# UNITED STATES PATENT AND TRADEMARK OFFICE

APPLICATION NO.	FILING DATE	FIRST NAMED INVENTOR	ATTORNEY DOCKET NO.	CONFIRMATION NO.
10/734,736	12/12/2003	Skye Lechner Wollenberg	501327.01	9587
7590 03/22/2005		EXAMINER		
Steven H. Arterberry, Esq. DORSEY & WHITNEY LLP			THOMPSON, HUGH B	
Suite 3400 1420 Fifth Avenue Seattle, WA 98101			ART UNIT	PAPER NUMBER
			3634	
			DATE MAILED: 03/22/2005

#### **DETAILED ACTION**

6) X Other: attached Figure

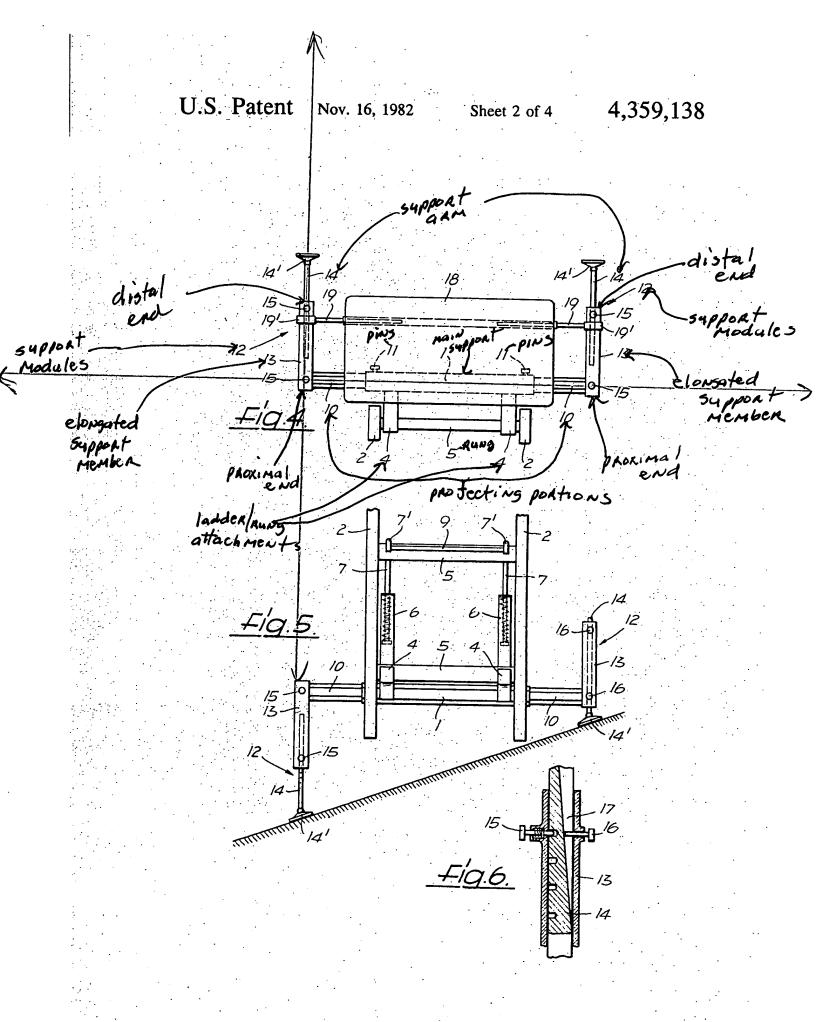
Claims 1-29 are rejected under 35 U.S.C. 102(b) as being anticipated by Kummerlin et al #4,359,138. Kummerlin et al, as best seen in Figures 1, 2, and 4, disclose a ladder attachment comprised of a ladder attachable main support 1, the ends of which serve as non-circular

coupling members that slidingly and axially receive projecting portions/engagement arms 10 of elongate support members 13, together along with support arms 14 form support modules 12, the support arms being attached to the elongated support members at a distal end located near the first set of locking pins 15, 16, opposite from a proximal end of the elongated support member that extends beyond (spaced apart from) and orthogonal to the projection portions/engagement arms 10, and securing mechanisms 11, which secure the projecting portions of the support modules to the main support 1.
